RE: CLARIFICATION NO. 3

Contract Title: Design, supply, installation and commissioning of STATCOMs and shunt devices on the KETRACO Network at Suswa and Rabai Substations (Lot 1 - Suswa 400/220 kV Substation & Lot 2 - Rabai 220/132 kV Substation)

Contract No.: KE-KETRACO-413024-CW-RFB

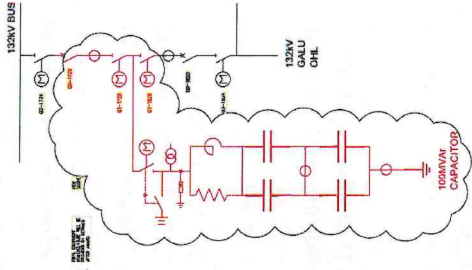
19.	<p>In reference to RABAI 220kV SUBSTATION GEOTECHNICAL REPORT, please clarify the following.</p> <p>a) SPT test results are not provided as per the standard methodology. The calculation of number of blows is not clear (Pg 25-27) as per shown below image, kindly provide the standard test results</p>	The Bidder is advised to perform preliminary geotechnical investigations to inform their bid price as the bid price shall cover all works necessary to perform the scope. The geotechnical reports provided as part of the Bidding Documents are for information purposes only.

Clarifications	Responses																																																																																																							
	<p>b) As per the Borehole detail, weathered sandstone encountered at shallow depth, No RQD values are provided, kindly provide the required values.</p> <p>c) There is a significant difference between the UCS test results on page 29 and the point load test results on page 30. Please confirm which values should be used for design purposes.</p>
